Addendum Number: 1.0

Addendum Issue Date: February 22, 2024

Project Name: Clarinda Correctional Facility – Kitchen & Laundry

RFB Number: 922300-03

1 LIFE SAFETY PLAN - LEVEL 1
SCALE: 1/16" = 1'-0"

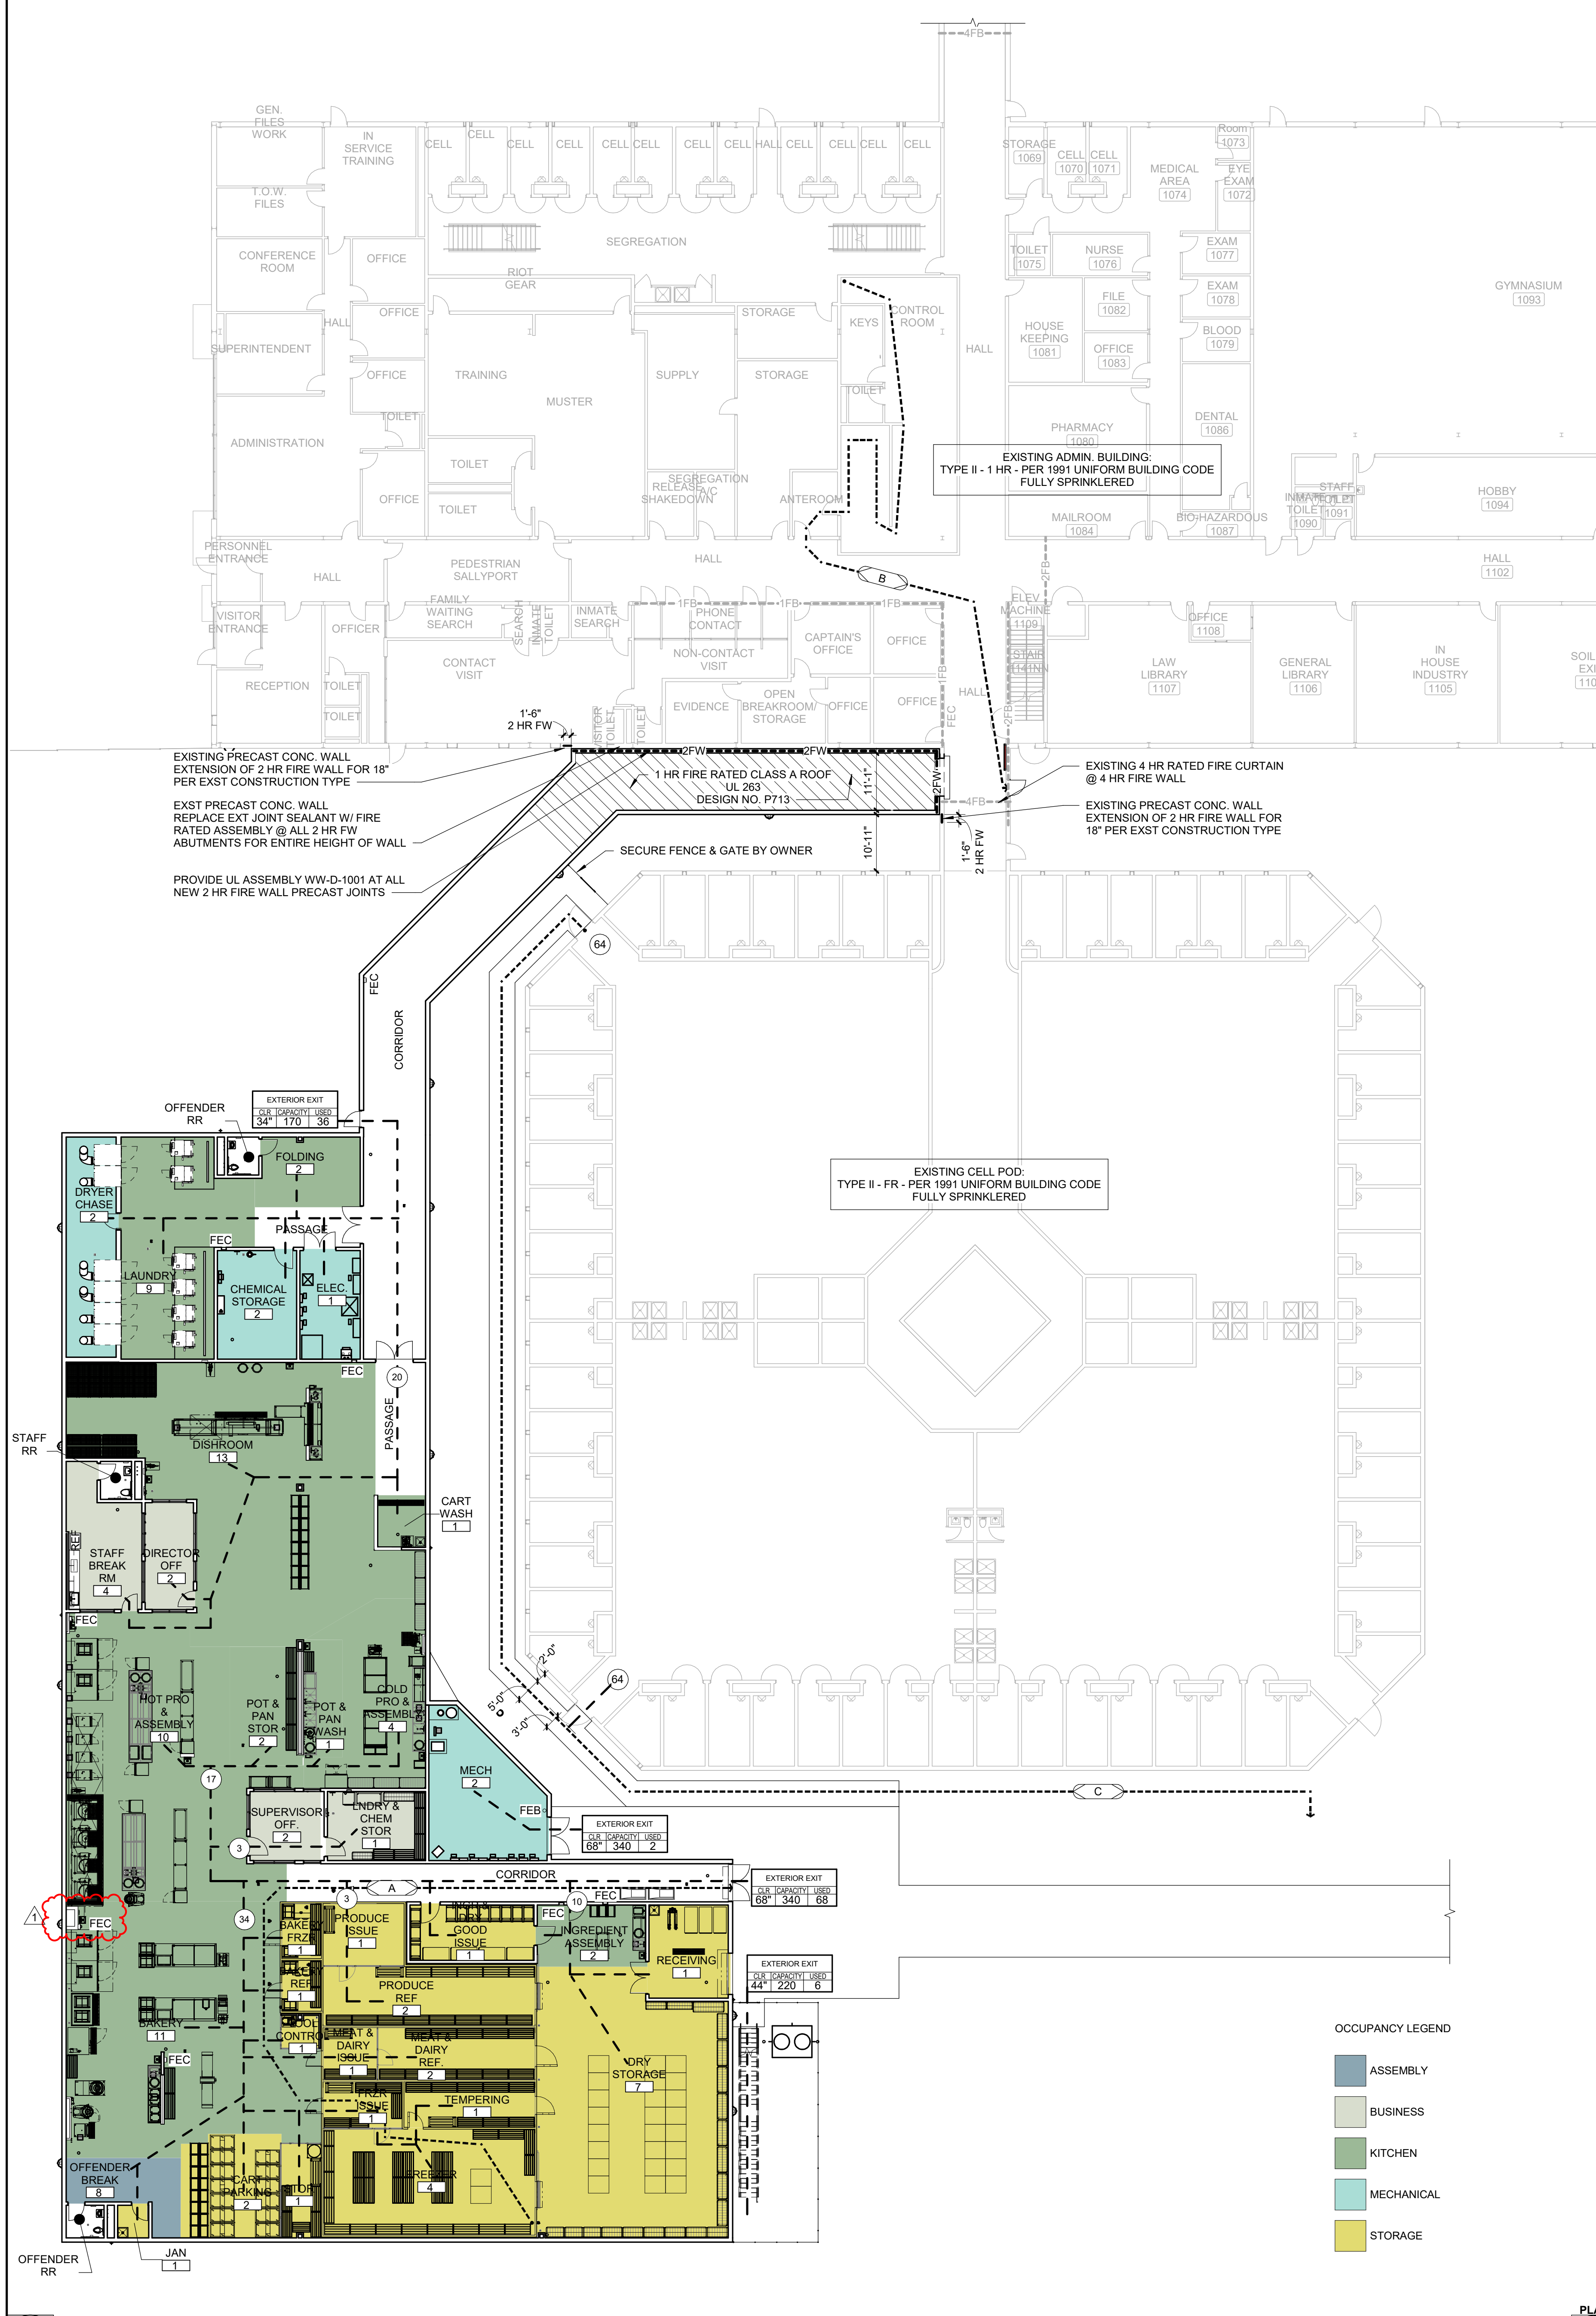
Item No. 2. LS1.1 – FIRST FLOOR LIFE SAFETY

Reference view 1 – LIFE SAFETY PLAN – LEVEL 1

1. **ADD** fire extinguisher cabinet as shown in updated attached sheet

1 FOODSERVICE EQUIPMENT PLAN - AREA 1
1/4" = 1'-0"

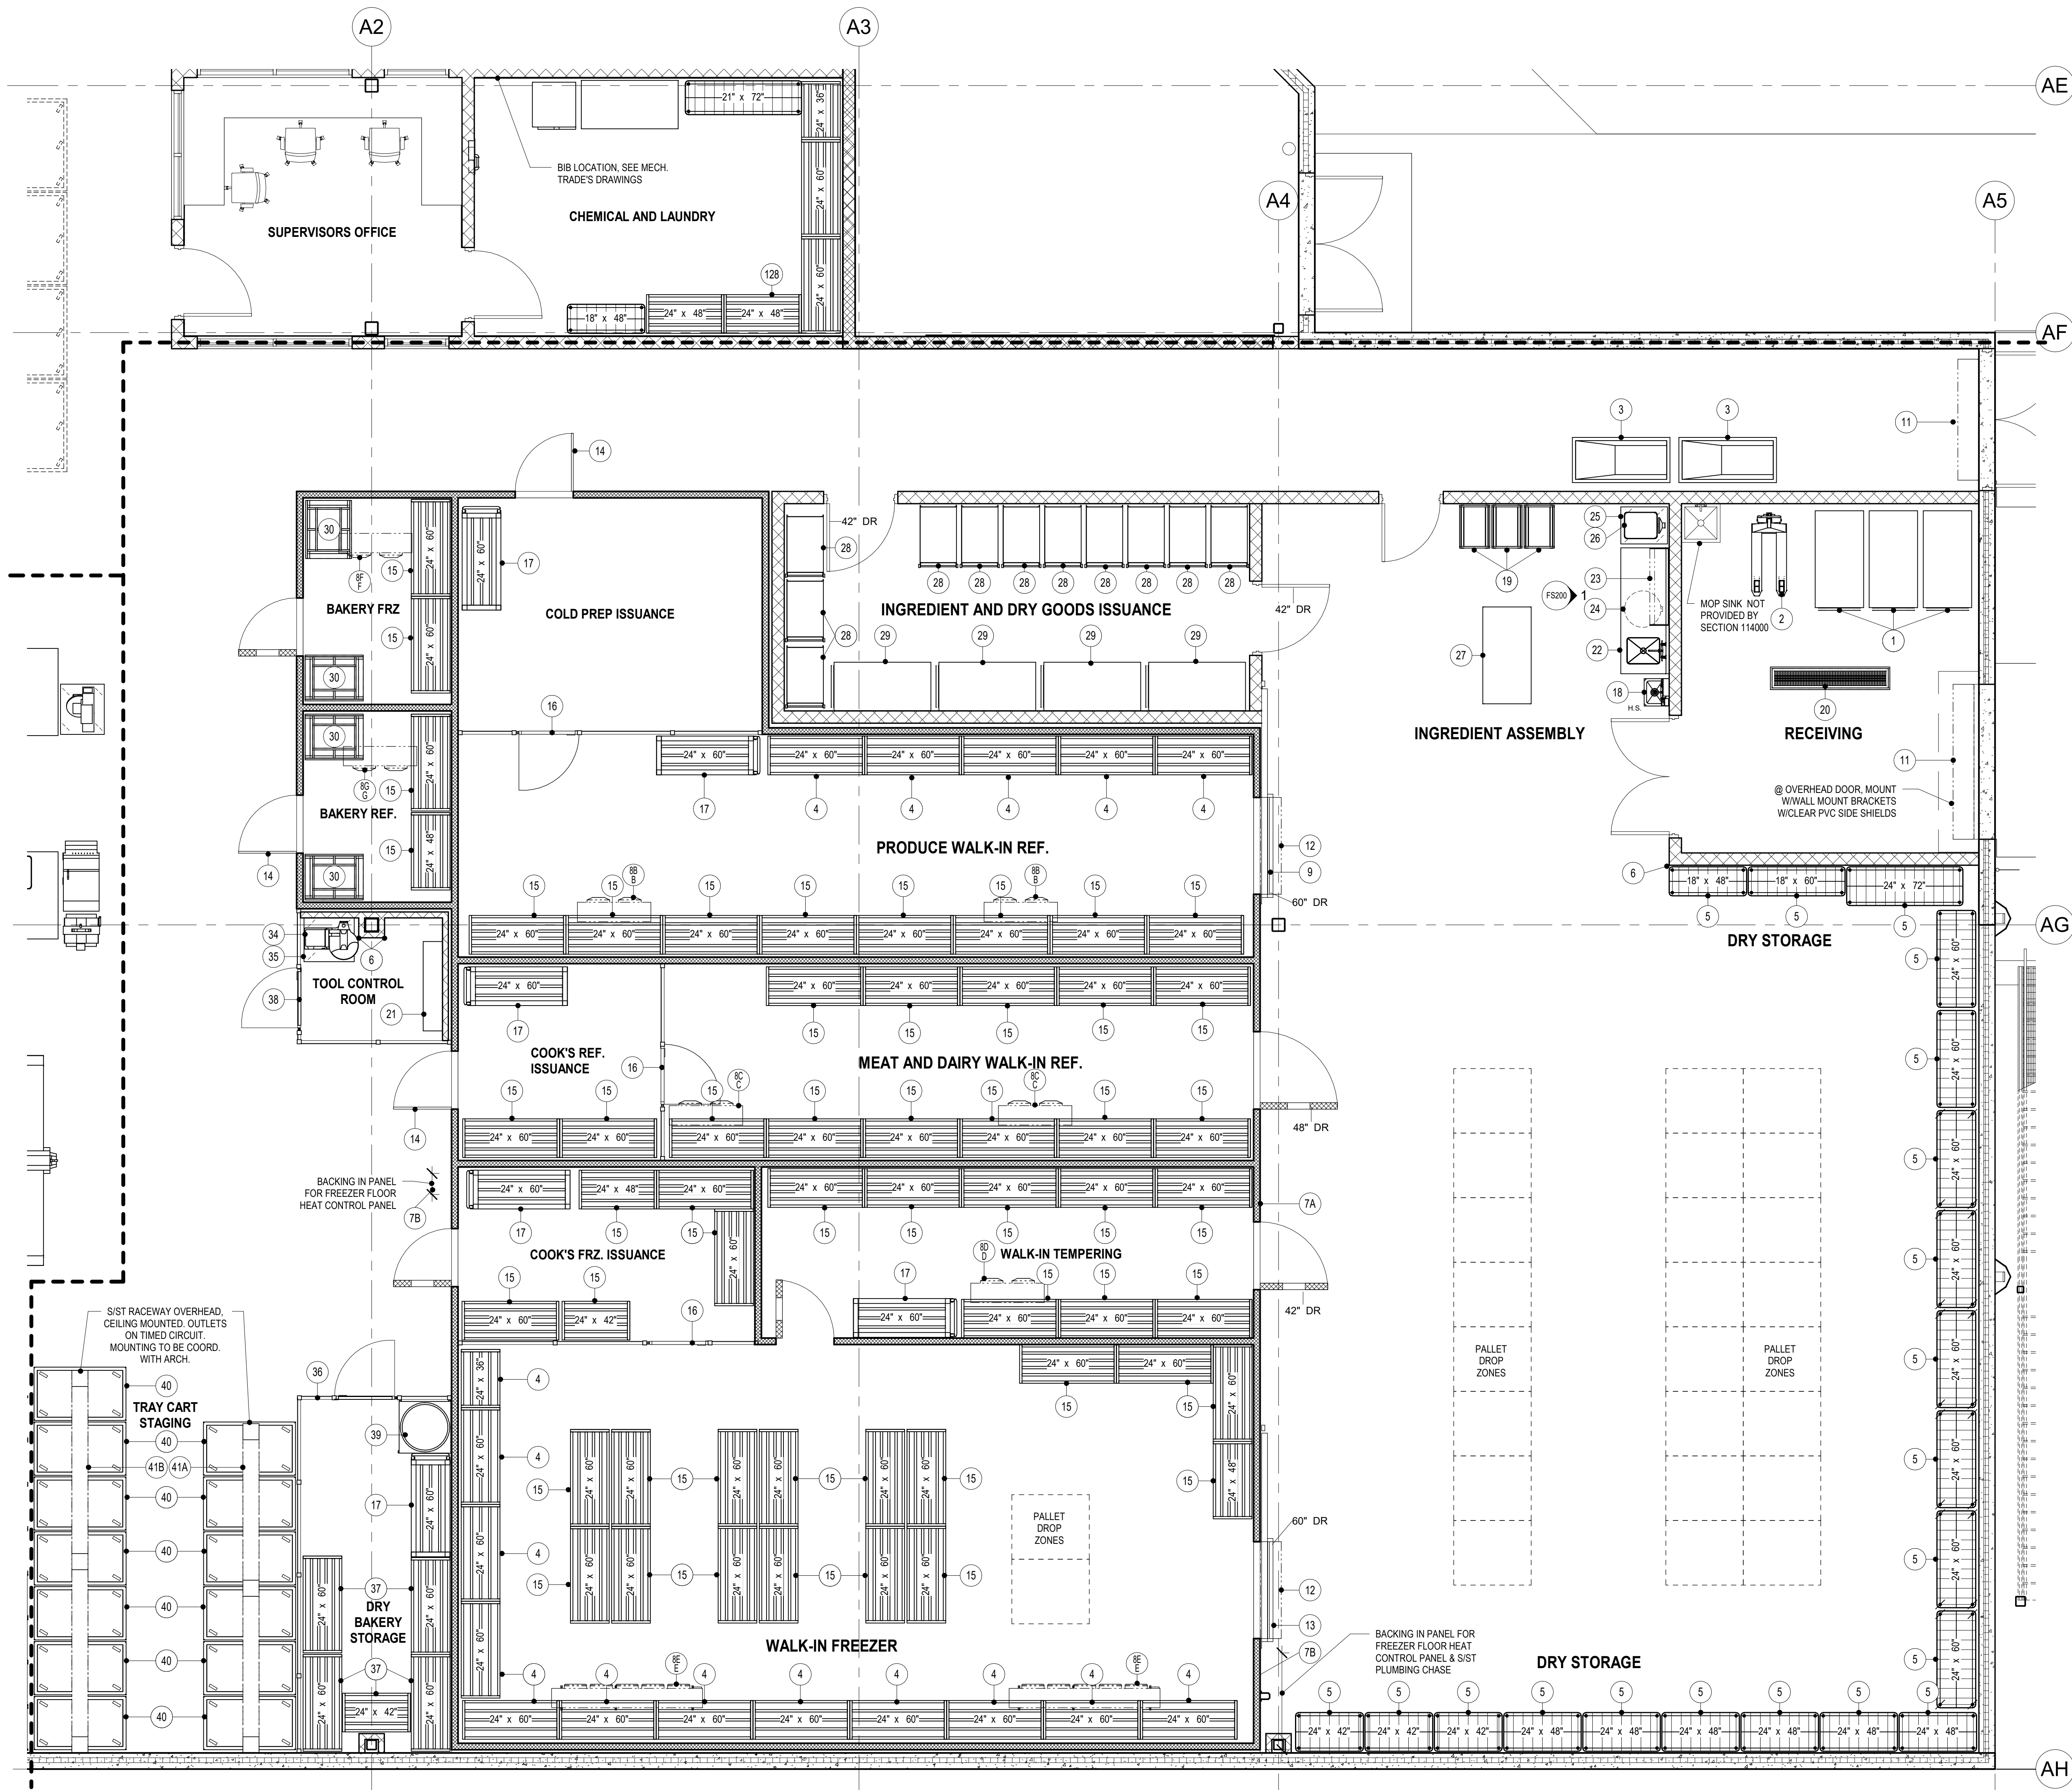
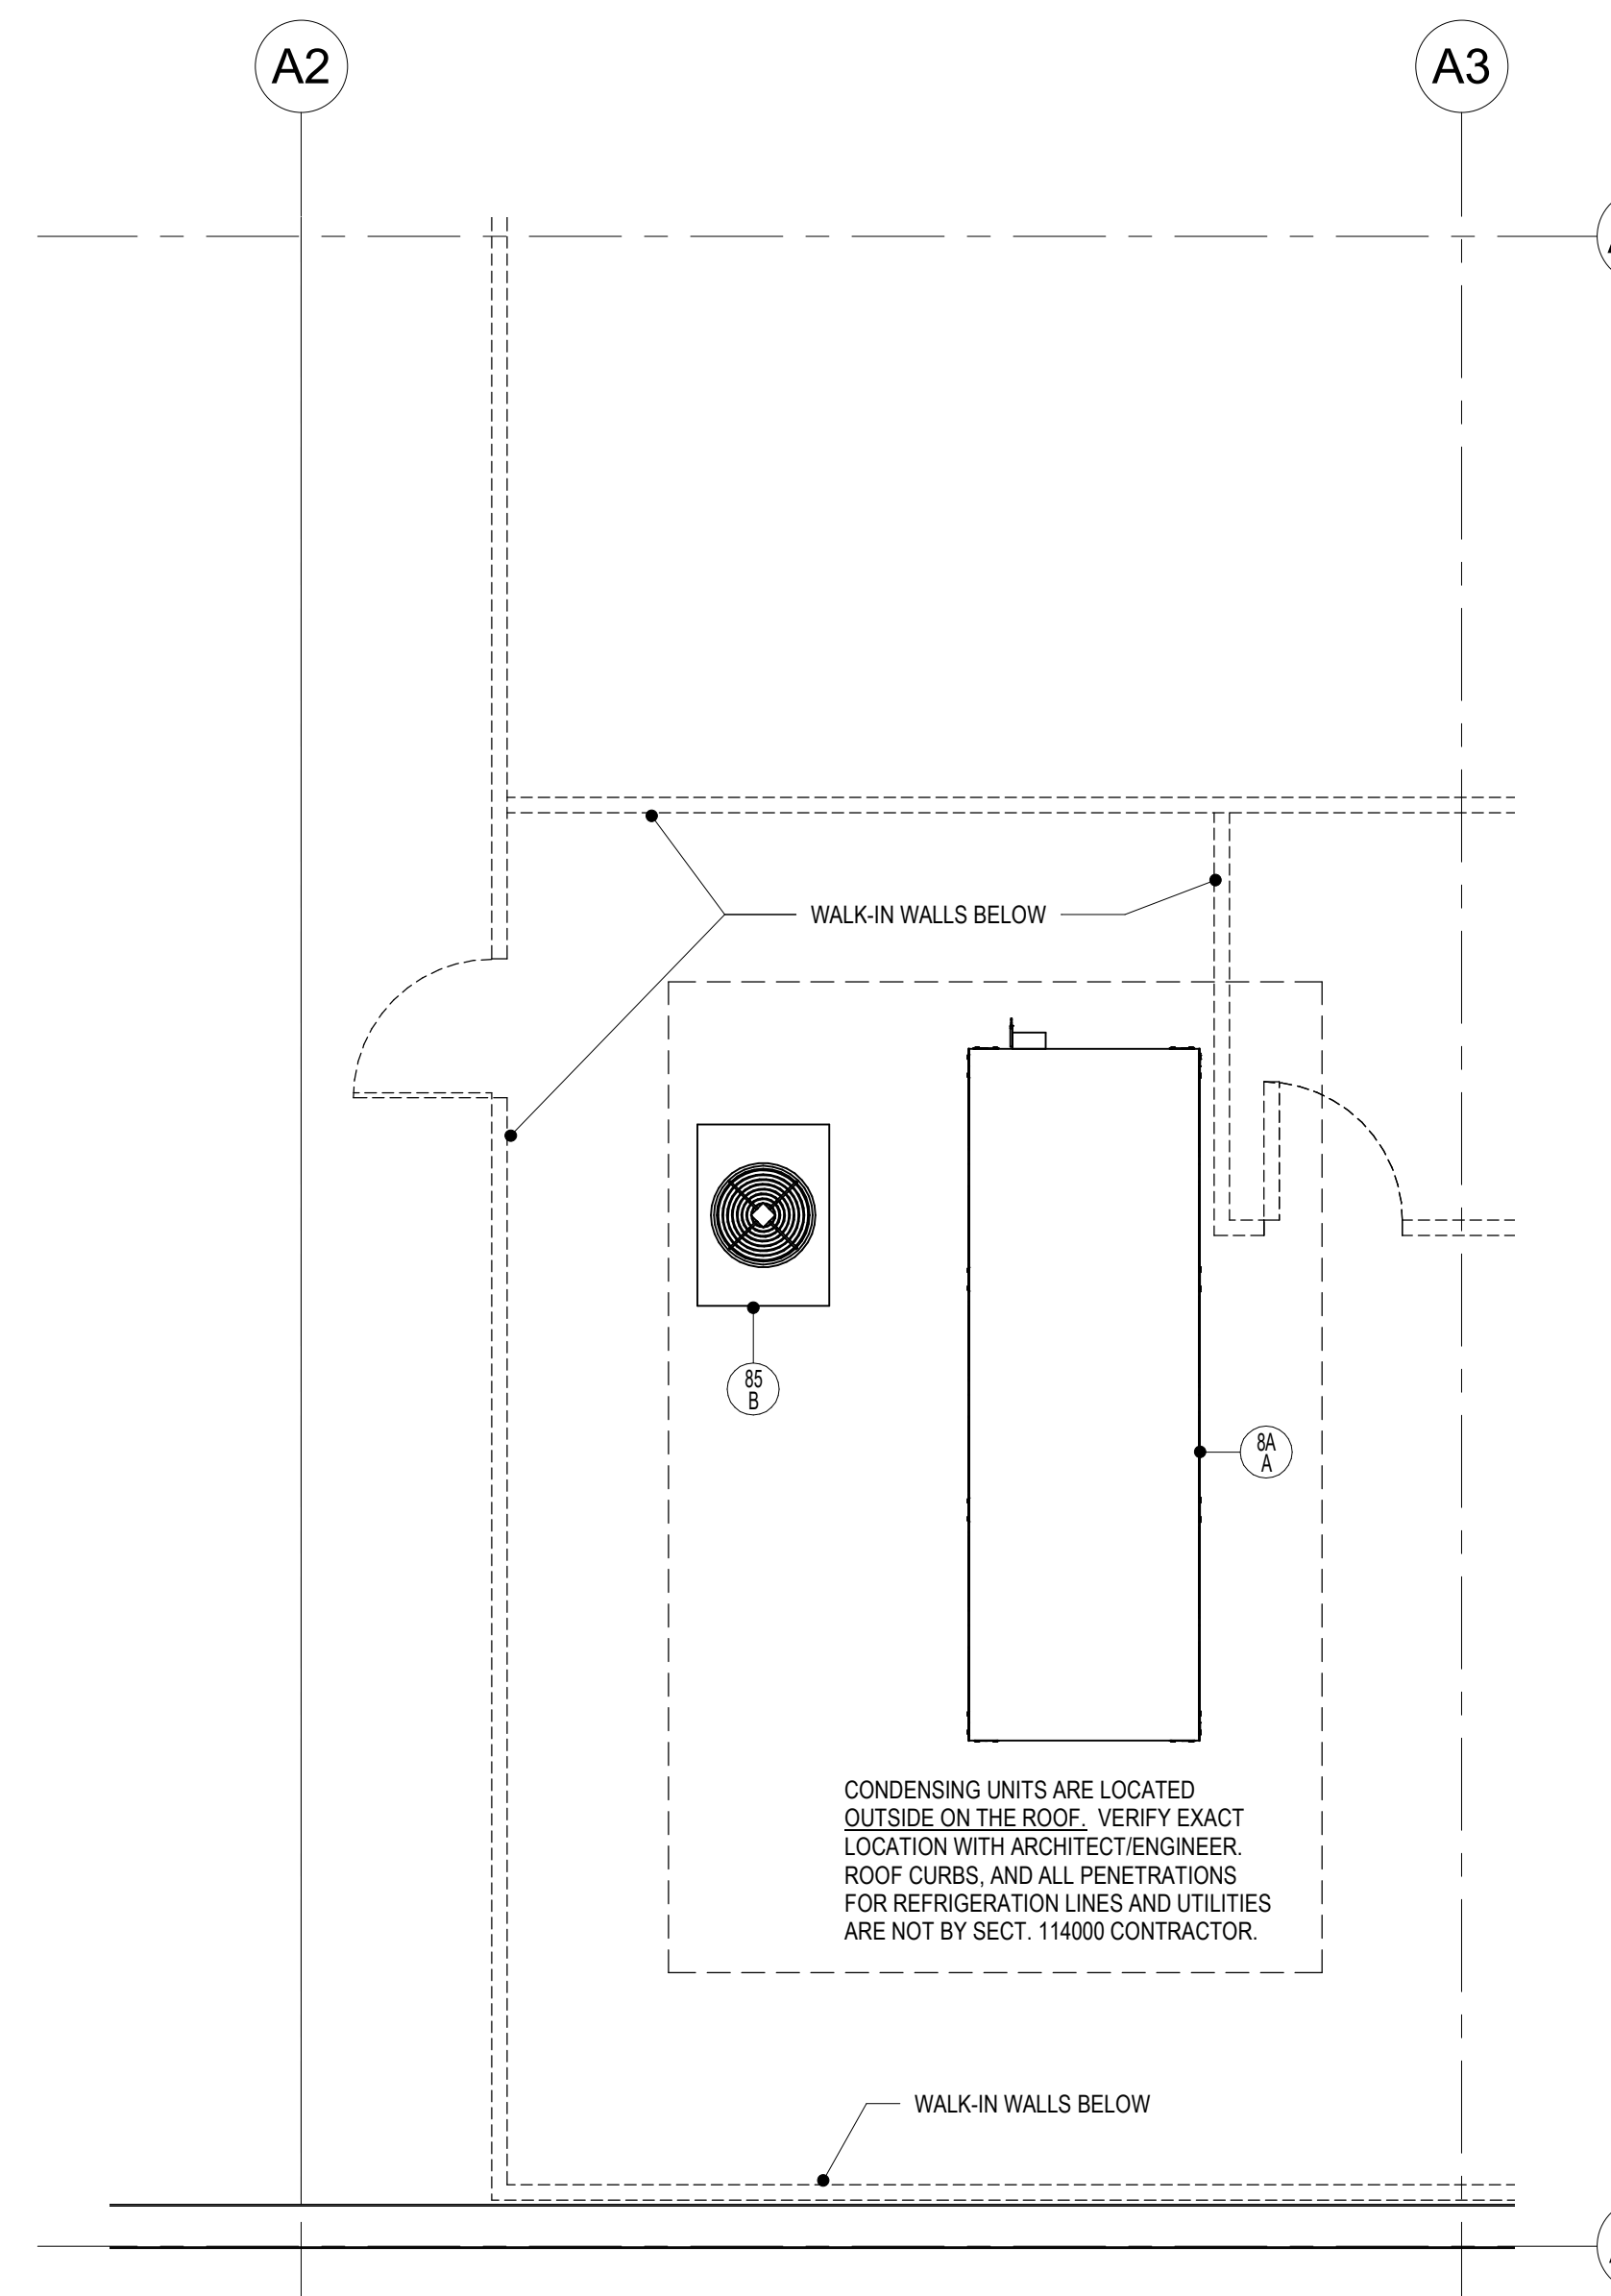
- Item No. 3. FS101 – FOODSERVICE EQUIPMENT PLAN AND SCHEDULE - AREA 1
Reference Foodservice Equipment Schedule – Area A
1. **REVISE** schedule as shown in updated attached sheet
- Item No. 4. FS102 – FOODSERVICE EQUIPMENT PLAN AND SCHEDULE - AREA 2
Reference Foodservice Equipment Schedule – Area B
1. **REVISE** schedule as shown in updated attached sheet
- Item No. 5. FS103 – FOODSERVICE EQUIPMENT PLAN AND SCHEDULE - AREA 3
Reference Foodservice Equipment Schedule – Area C
1. **REVISE** schedule as shown in updated attached sheet
- Item No. 6. FSE100 – FOODSERVICE EQUIPMENT ELECTRICAL SCHEDULE & DETAILS
Reference Foodservice Equipment Electrical Schedule
1. **REVISE** schedule as shown in updated attached sheet
- Item No. 7. FSM100 – FOODSERVICE EQUIPMENT MECHANICAL SCHEDULE
Reference Foodservice Equipment Mechanical Schedule
1. **REVISE** schedule as shown in updated attached sheet
